SVS-04-09
2/12/2009**TO: ALL DISTRIBUTOR & DEALER SERVICE PERSONNEL****SUBJECT: POTENTIAL OIL LEAK – 4L SERIES ENGINE GEAR CASE PTO SHIPPING COVER****BACKGROUND INFORMATION**

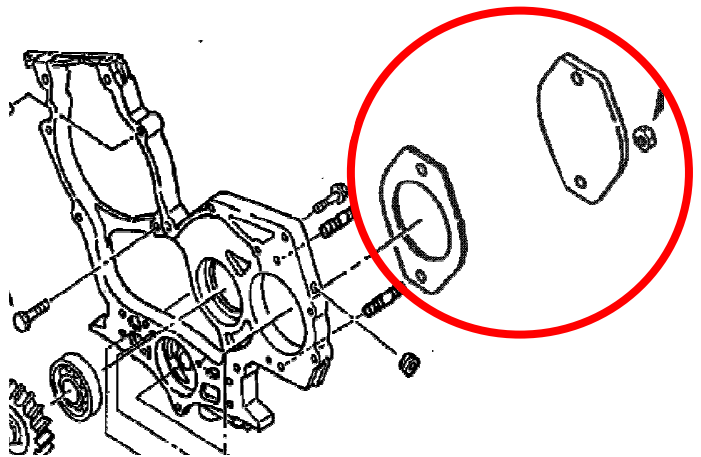
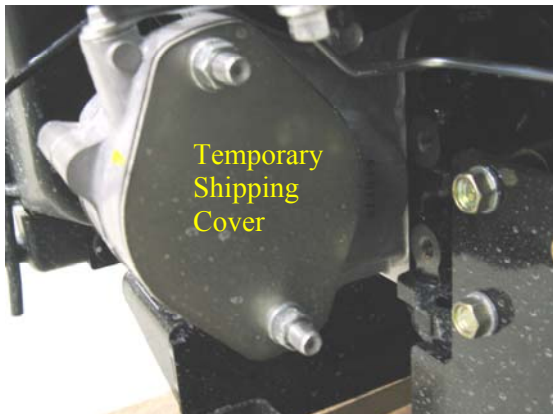
Isuzu engines are designed to have the gear case PTO port utilized; however, this port may not be utilized in some circumstances. The gear case PTO port is shipped from the factory with a loosely fitted cover. It can be used as a permanent cover; however, it **must** be re-sealed and tightened or otherwise an oil leak may occur.

Inspect gasket for reuse; if reusable, re-install with sealant and torque to 41-55N·m. If the gasket is **not** reusable, replace with an appropriate **new** Isuzu gasket and re-install with sealant; then torque fasteners to 41-55N·m.
